PUBLIC ART DONATION REVIEW PROCESS

Proposed Donation of “The Homecoming”

Parks and Recreation Board
August 27, 2013

Location

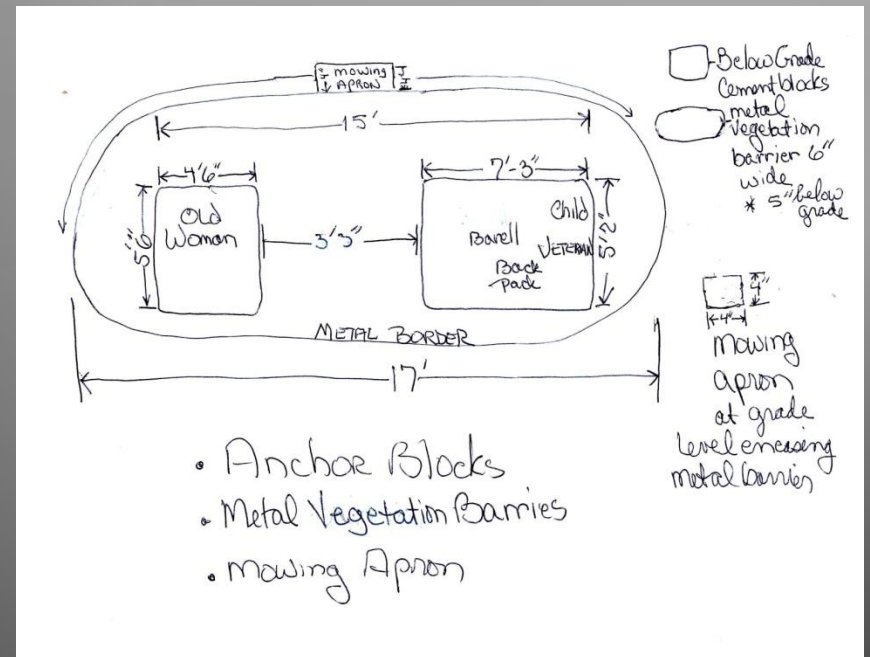
- ▶ The art work will eventually be in a critical root zone as the adjacent tree grows in size.
- ▶ The proposed site interferes with the riparian buffer zone which may soon be fenced to protect the zone.
- ▶ The site may become inaccessible to the public.
- ▶ Auditorium Shores proposed improvements.

- ▶ Art Donors suggested that the site would need to be excavated to install the concrete base. However, staff recommend concrete piers.
- ▶ The art work is at ground level posing a potential climbing risk for the public.
- ▶ The entire shoreline is undergoing a Master Plan Process beginning in the Fall of 2013.
- ▶ PARD will consider proposals for other sites should the donor wish to re-apply.

- ▶ “The proposed site is unacceptable from an environmental standpoint...”
- ▶ “The site (less than 10 ft. from the shoreline Lady Bird Lake) needs structural certification to ASCE 24-05 Flood Resistant design and construction standards, as well as needing to show ‘No adverse impact’ for the work.”
- ▶ “The site is in the riparian zone of Lady Bird Lake, where WPD is establishing a ‘Grow Zone’ to enhance and protect shoreline vegetation.”
